# BANNOCKBURN SOUTH EAST PRECINCT STRUCTURE PLAN

Draft Amendment C107gpla Exhibited Documentation  
Ramsey Property Group Submission  
June 2025

# REQUESTED CHANGE #1: ALTERNATE DRAINAGE STRATEGY

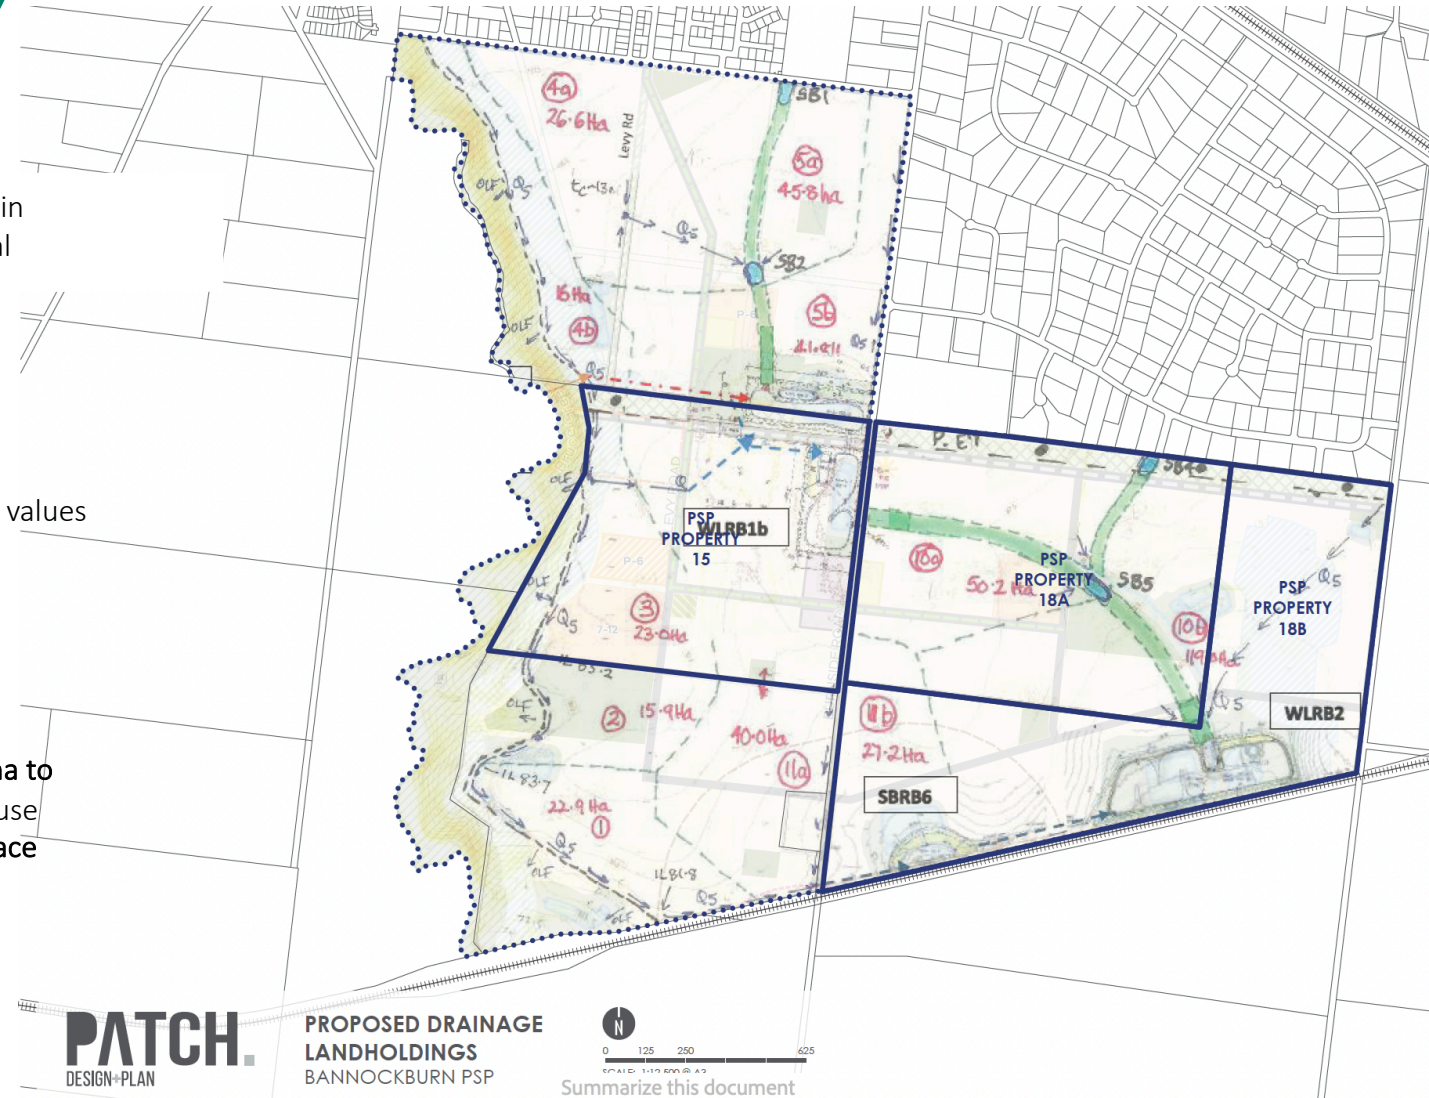
The current drainage strategy has 54Ha of waterway and drainage reserve within the precinct with a total cost of \$99,264,832, which equates to 30% of the total DCP.

- Drainage is 17% of the NDA
- \$320,809 p/NDA Ha drainage contribution to the DCP
- Basins located adjacent to Bruce Creek have cultural values and ecological values
- Vic Track do not support the current proposal

Adopt the Neil Craigie Drainage Strategy which reduces the land take from 54ha to 33Ha and reduces the construction costs by 33%. This is a more efficient land use and will result in a reduction to the DCP of \$167,117 p/NDA Ha. Amend the Place Based Plan to reflect the alternative drainage strategy.

# REQUESTED CHANGE #2: REMOVE CL-01

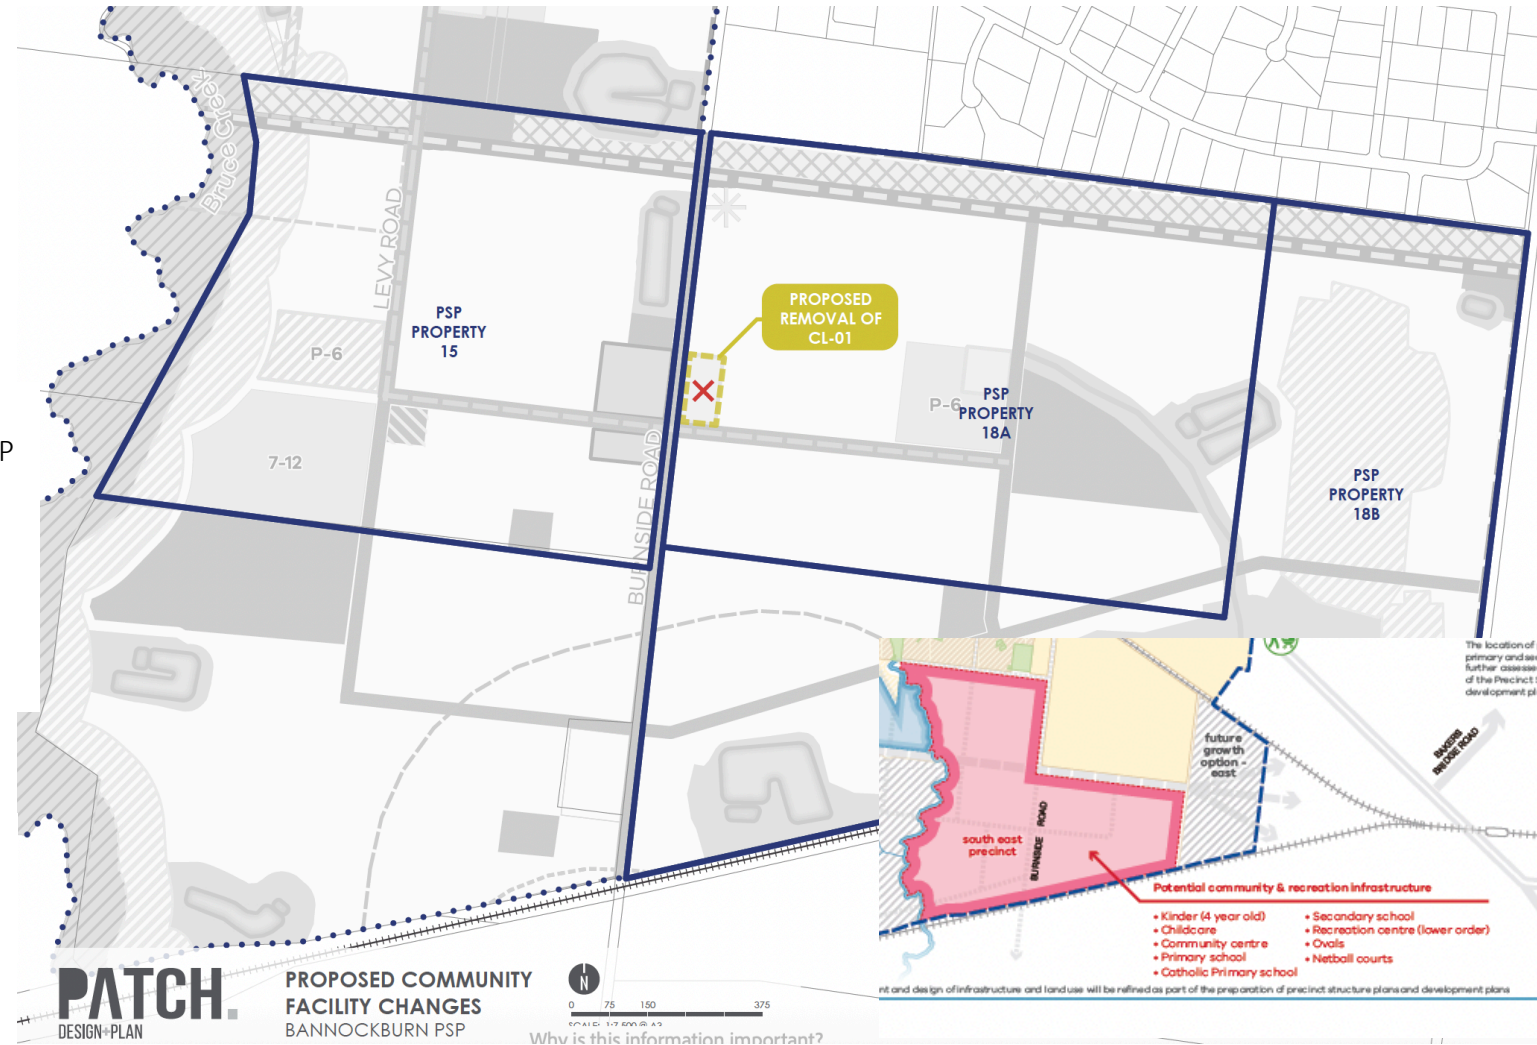
CL-01 is a community facility that is not co-located with a school or active open space. There are also three other nearby community facilities within the PSP. A total of 3 community facilities and 1 Indoor Recreation Centre have been identified on the Placed Base Plan.

- There is an over provision of community facilities
- \$139,000 p/NDA Ha community facilities contribution to the DCP
- It is not co-located with a school or open space
- Location will give community expectation of early delivery
- Within 800m radius of two other community facilities and an indoor recreation centre
- There is no strategic justification in the Growth Plan for 3 community facilities

Remove CL-01 and update costs to benchmark cost for community facilities. This is a more efficient land use and will result in a reduction to the DCP of \$126,098 p/NDA Ha.

# REQUESTED CHANGE #3: REDUCE SR-02

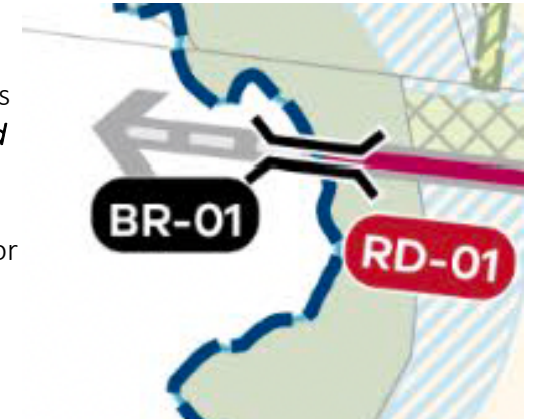
- There is an over provision of active open space, which contributes to the significant DCP.
- The remaining open space portion has no funding allocated to activate it.
- \$258,158 p/NDA Ha Recreation provision contribution to the DCP

**Reduce SR-002 from 6Ha to 3Ha.** This is a more efficient land use and will result in a reduction to the DCP of \$28,039 p/NDA Ha. Remove the 3 hectare portion of the active open space that has no facilities on it, in accordance with Taylors plan, sketch 2.

# REQUESTED CHANGE #4: REMOVE BR-01 FROM DCP

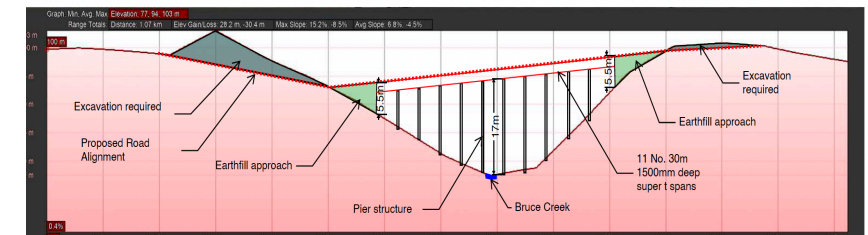
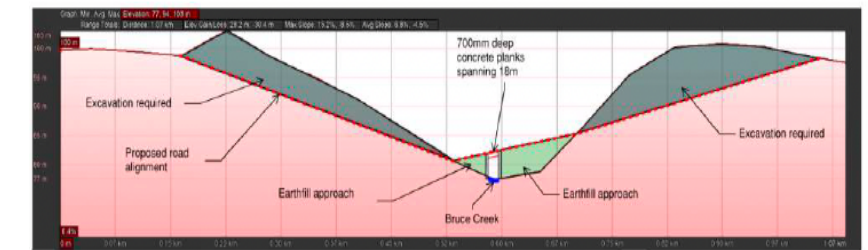
This bridge proposed between the Bannockburn SE PSP and the Future Growth Option South will not be delivered in the time horizon of this PSP. VPA Infrastructure Development Staging Plan Background Document April 2025 states that the *“Road Bridges BR-01 should be delivered to align with the development of the Bannockburn South West Precinct and Future Growth Option South. Anticipated need is long term.”* The Jacob’s report identified 2 bridge design options with Option 2 proposed for DCP contribution instead of Option 1 which is far less expensive and noting, the cost of Option 1 has been omitted from the Jacob’s report exhibited. Furthermore, the traffic reports prepared for the Growth Plan and the PSP suggest approximately 13% of the traffic usage of the bridge in the final design will be generated by this PSP.

- The bridge will not be delivered in the time horizon of this PSP.
- The bridge included in the DCP corresponds to Option 2 in the Jacobs report and is costed at \$79,984,050; however, the smaller and more cost-effective alternative Option 1 could be delivered
- The anticipated use of the bridge by future residents in this precinct is very limited, highlighting a weak nexus between the bridge infrastructure requirement and the precinct.
- Numerous reports have been commissioned in response to longstanding concerns about heavy haulage trucks using the main street of the township; the significant cost of delivering an alternative arterial road to address this existing issue should not be transferred to this precinct, which is not the source of the problem

Remove cost of bridge BR-01 construction from the PSP. This will result in a reduction to the DCP of \$129,248 p/NDA Ha. Alternatively apportionment of the bridge needs to be in accordance with the traffic volumes generated by the precinct over the bridge and adopt Jacobs Option 1 which is more cost effective.

# REQUESTED CHANGE #6: REDUCE SR-01 & SR-03 & BETTER UTILISATION OF TRANSMISSION EASEMENT

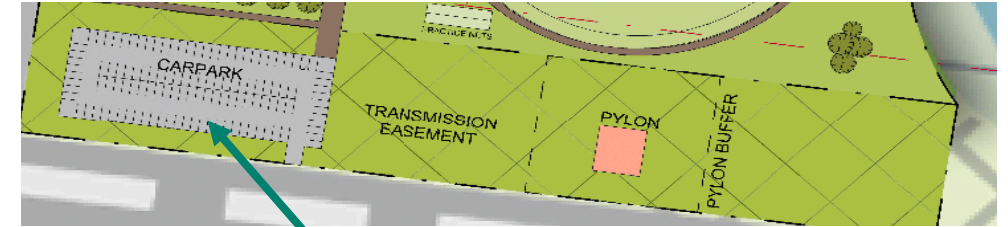
There are three active open space areas in the Precinct. The indicative open space design for SR-02, Sketch 2 prepared by Taylor as shown in Appendix B of the Bannockburn DCP Document (pg 66) utilises 3 Ha of the 6 Ha of proposed reserve with the remaining 3 Ha not being utilised. Further, there is no funding allocation in the DCP for the remaining 3Ha of open space.

- There is an over provision of active open space, which contributes to the significant DCP.
- The remaining open space portion has no funding allocated to activate it.
- The Active Open Space under the transmission easement significantly under utilizes the easement despite Ausnet Guidelines allowing many active open space uses within the easement as noted here.

# REQUESTED CHANGE #7: INCLUDE SENSITIVE AREAS IN DCP CALCULATION

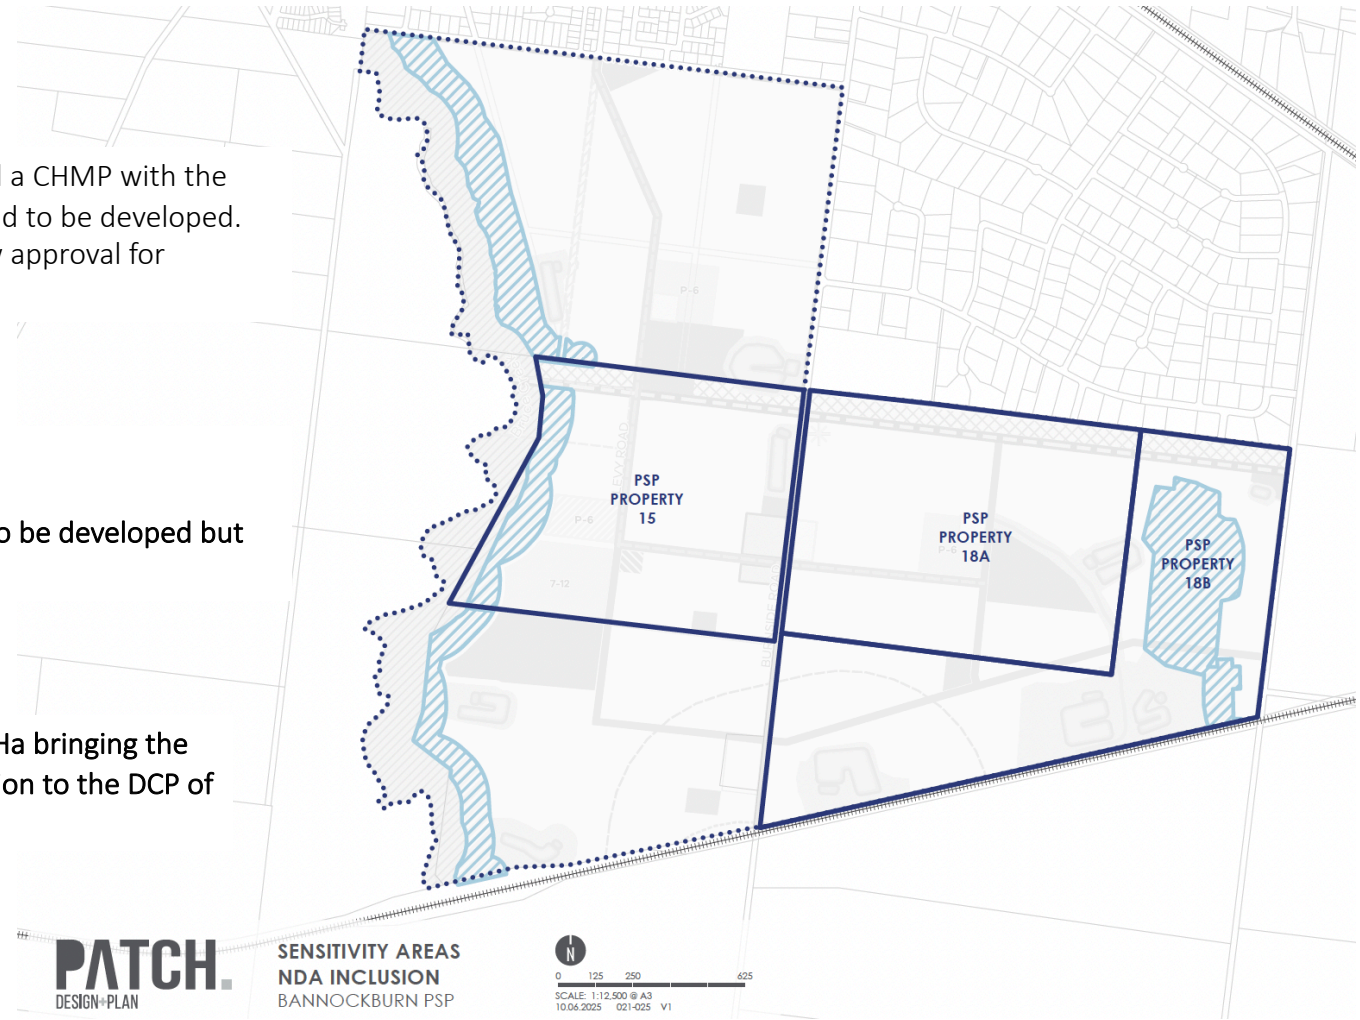
The sensitive areas will be subject to a process with DEECA under the EPBC Act and a CHMP with the Waddawurrung. However, neither of these processes exclude the ability for this land to be developed. Both processes have a clear pathways under the EPBC Act and the AAV Act to allow approval for development.

# REQUESTED CHANGE #8: REMOVAL OF MODERATE VALUE TREES

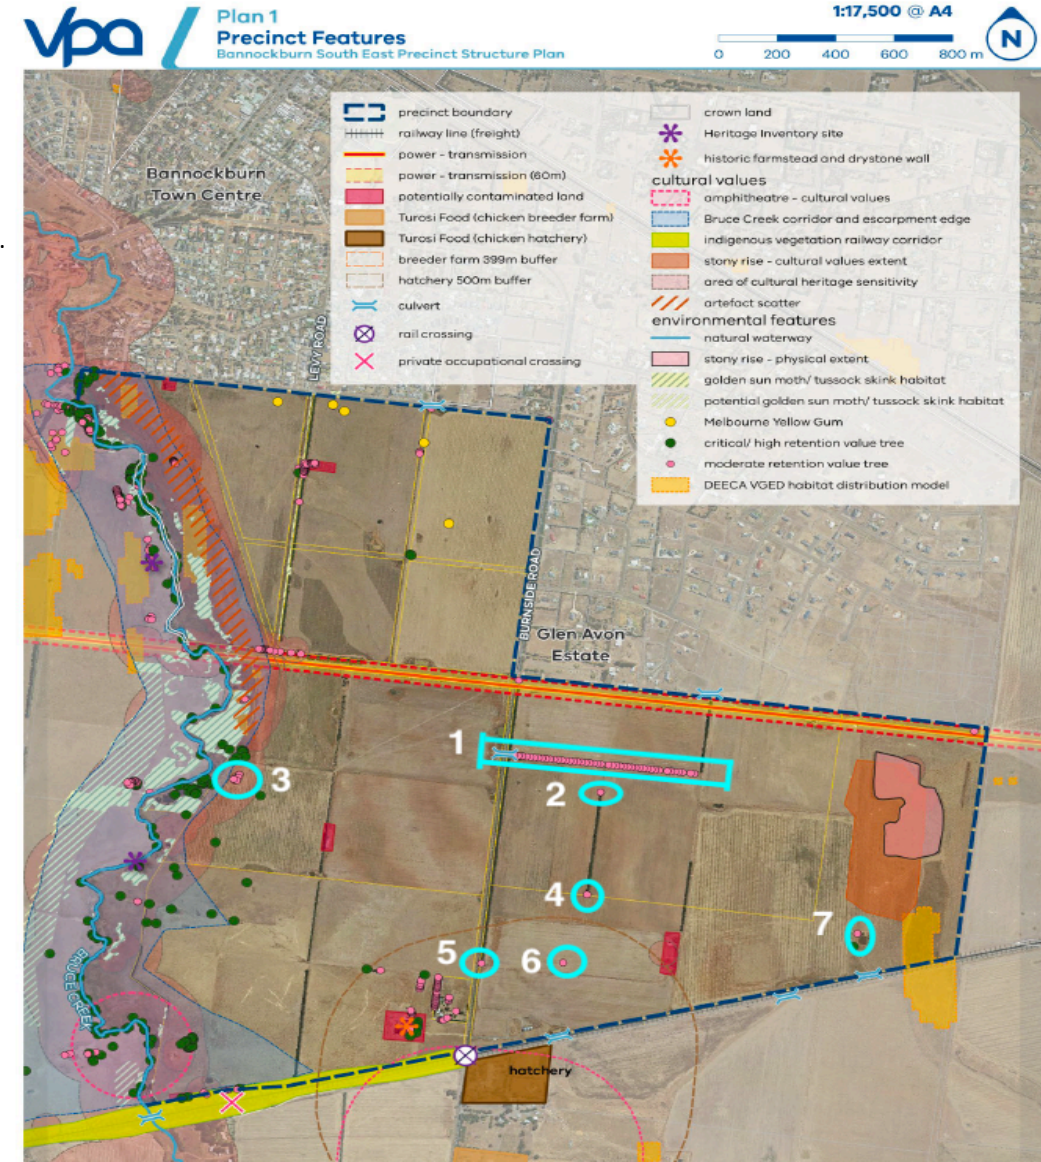
The moderate retention trees within our landholding have previously been identified as weeds & noxious. Request removal from the plan as it will unnecessarily complicate the statutory planning process.

- 1 – Row of Desert Ash (*Fraxinus angustifolia* subsp. *Angustifolia*) is listed as an environmental weed of Very High Risk in Victoria.
- 2 & 4 – These trees are Monterey Cypress (*Hesperocyparis acrocarpa*) & are listed as environmental weeds in Victoria by DELWP
- 3 – These Pepper Trees (*Schinus molle*) and Monterey Cypress (*Hesperocyparis acrocarpa*) are both listed as environmental weeds in Victoria by DELWP
- 5 & 6 - These Monterey Cypress (*Hesperocyparis acrocarpa*) are listed as environmental weeds in Victoria by DELWP
- 7 - The Weeping Willow (*Salix babylonica*) is listed as a noxious weed and is restricted in Victoria under the catchment and land protection act and the Sugar Gum is listed as an environmental weed.

Remove all moderate retention trees within our landholding from the plan.

# REQUESTED CHANGE #11: REMOVE HATCHERY BUFFER

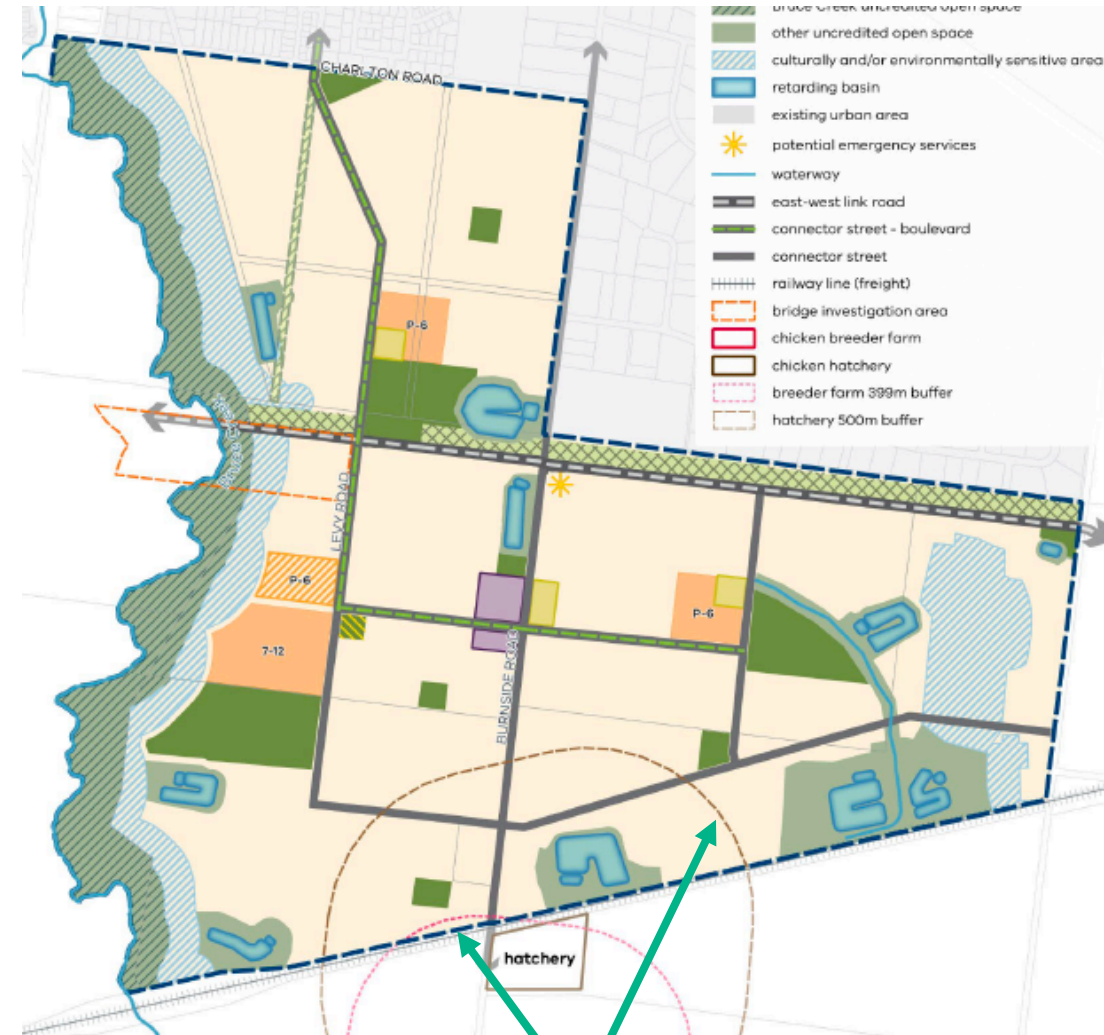
The EPA have recommended a buffer to Turosi Foods hatchery and breeder farm. RPG and Netherby's have undertaken an Odour Assessment to determine whether a buffer is necessary. Following a meeting with PJRA, EPA, VPA, RPG and Netherby's where PJRA presented the findings of the Odour Assessment which has determined that no buffer is required.

- Remove Hatchery and Breeder Buffers from all PSP Plans
- Remove any Requirement and Guidelines associated with the buffer
- Remove any reference to the buffer in the Planning Controls and any associated documentation

**Figure 1** SWMS layout as proposed by Alluvium 2025.

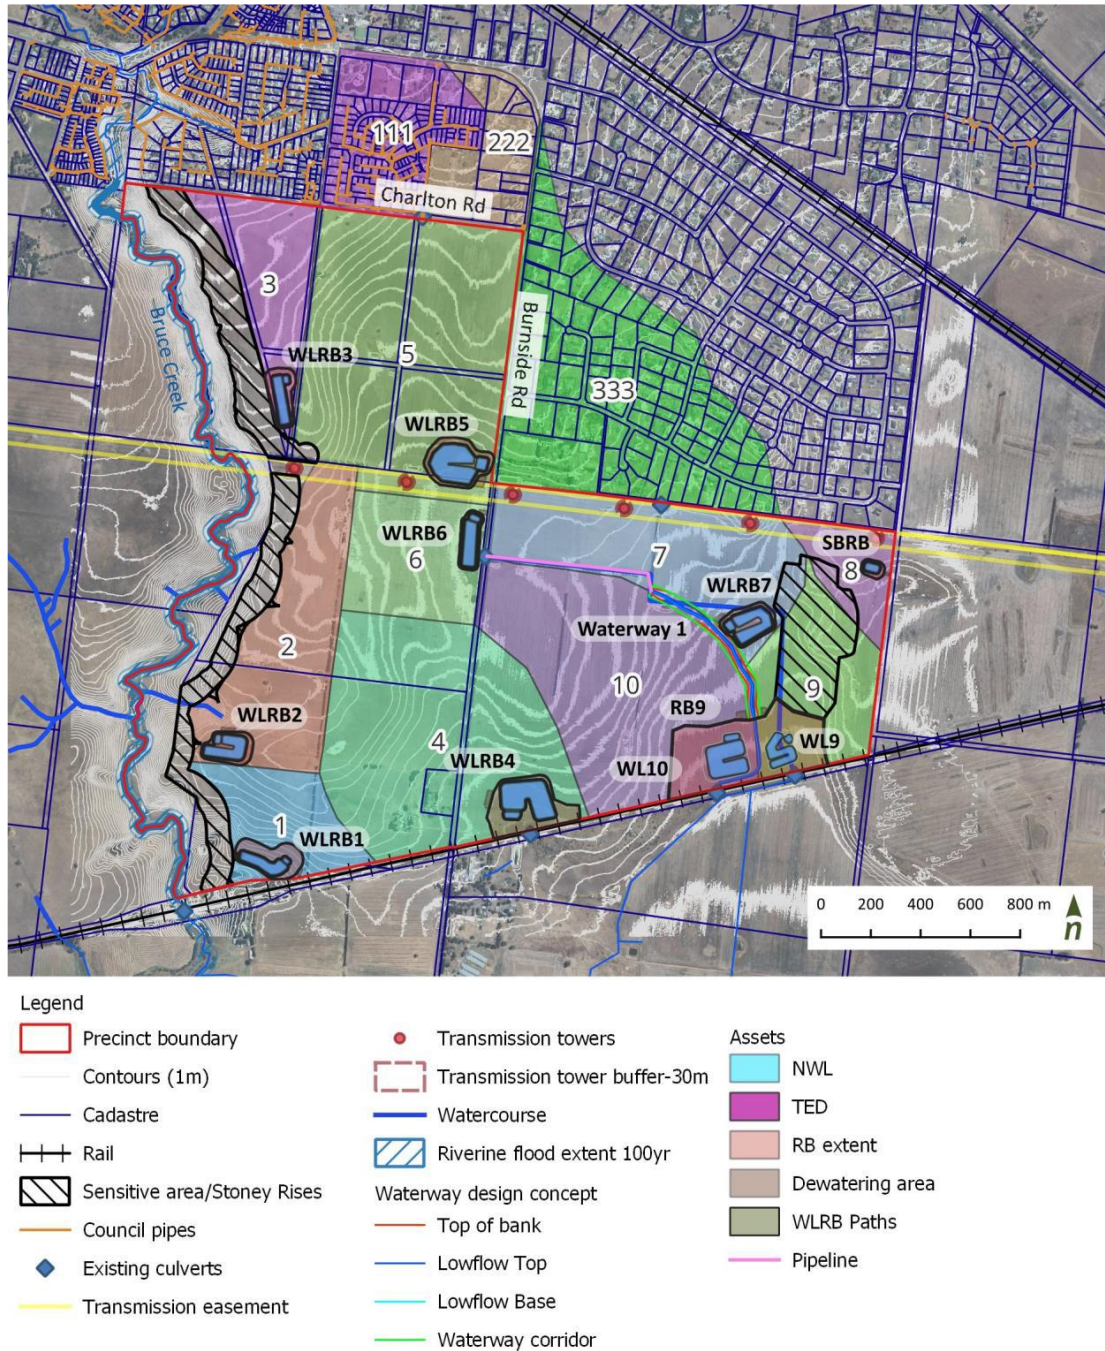
I refer to your request for me to review and provide comment on the stormwater management approach taken by Alluvium (see Figure 1) and to provide advice on a preferred alternative strategy which would enhance developable land area and resolve other issues.

1. Assets shown along the Bruce Creek frontage are poorly located, will sterilise potential developable land (the “sensitive area”), require pipelines down very steep valley slopes, and will not comply with EPA 1739.1 because of greatly increased volumetric runoff.
  - *WLRB1 concept is located on steeply sloping land and does not show where the outlet will go to Bruce Creek.*
  - *WLRB2 concept is located on a spur of high land with no outlet shown on very steep slopes. Major excavation required to service abutting land.*
  - *WLRB3 concept is squeezed into a very narrow site on another spur with no outlet shown.*
2. Assets WLRB1-3 are not required anyway and Alluvium are incorrect in stating that it is not possible to provide drainage services to land shown along the Bruce Creek frontage as the “sensitive area”.
